Project: CITY OF CREST HILL - WEST SEWAGE TREATMENT PLANT IMPROVEMENTS

Change Order Request #: 037

Cost Proposal Request
West Sewage Treatment Plant Improvements
City of Crest Hill
Contract 1-2022
March 12, 2025

COST PROPOSAL NO.: 037

037-02 Drawing C45-P1.01 (Sheet 126)

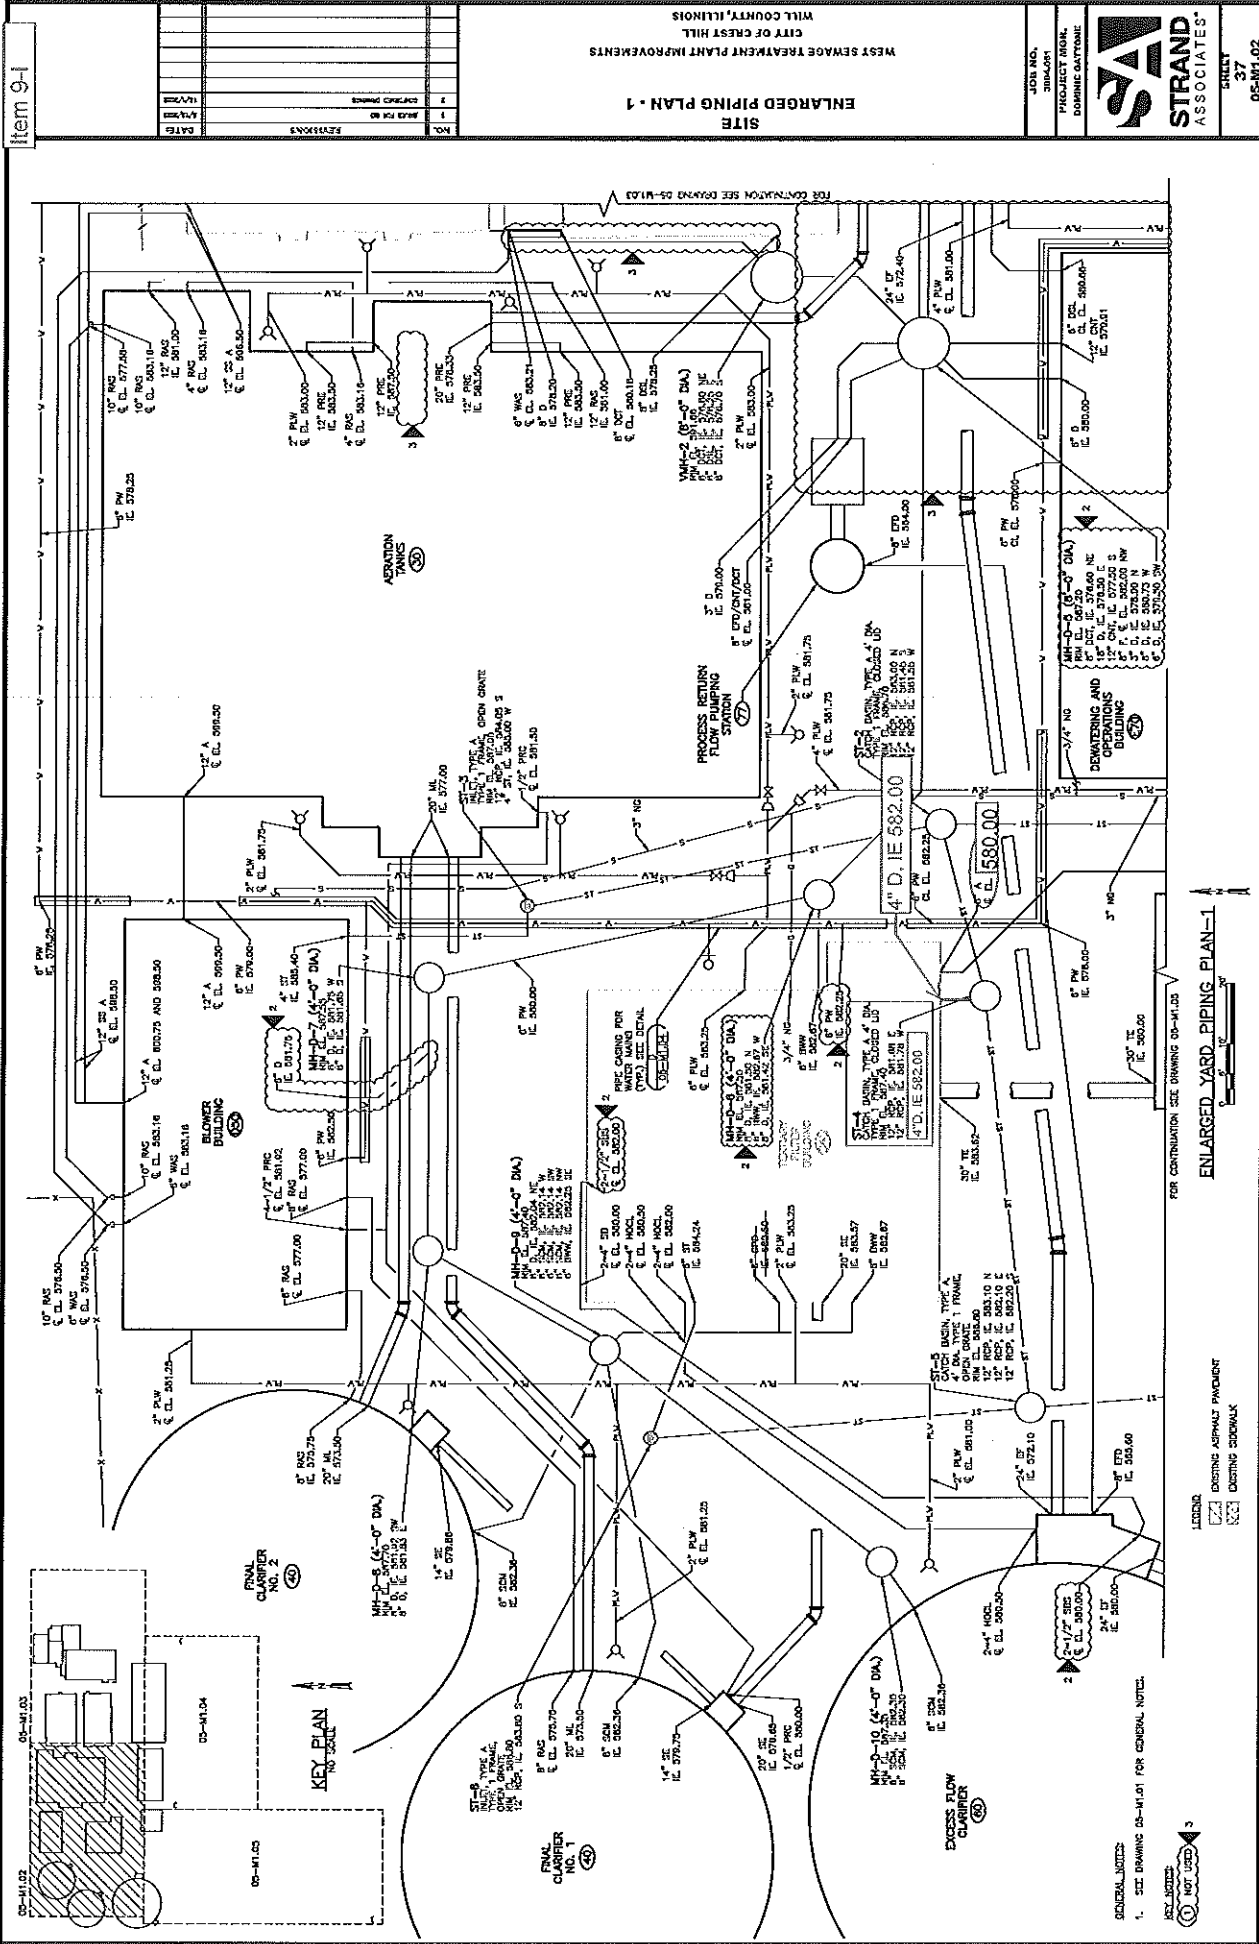
The intent of this cost proposal request is to redirect the C45 Filter Building roof drain piping in the vicinity of the tertiary filters.

Cut existing piping and run new piping as high as possible on south wall. Connect piping to ST-4 at 582.00. Reduce pipe diameter to 4-inch inside building.

Remove and cap northerly run of roof drain piping as shown below on Sheet 126 - C45-P1.01.

PLUMBING PLAN
TERTIARY FILTER BUILDING

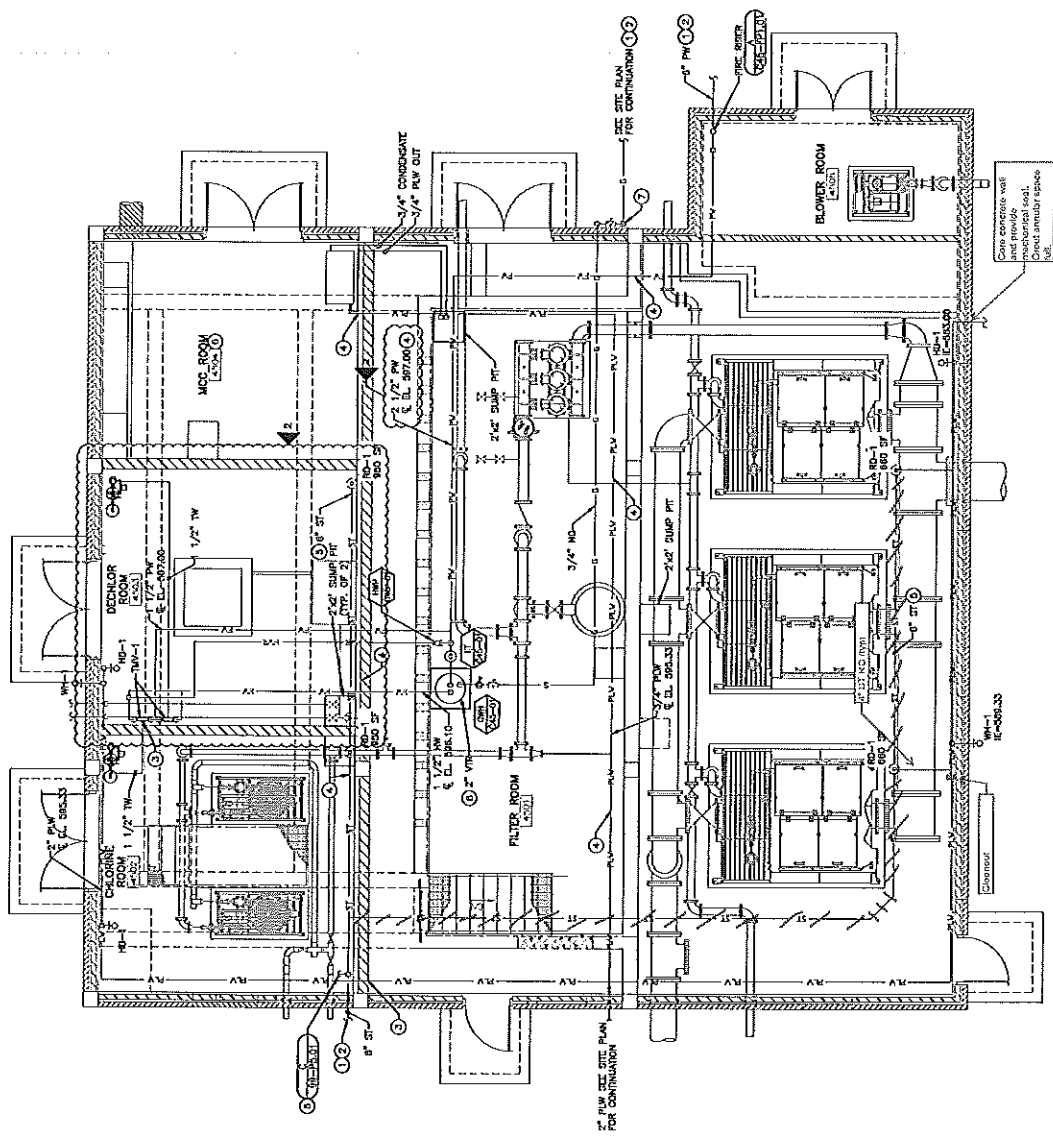
See comments on attached PDF.
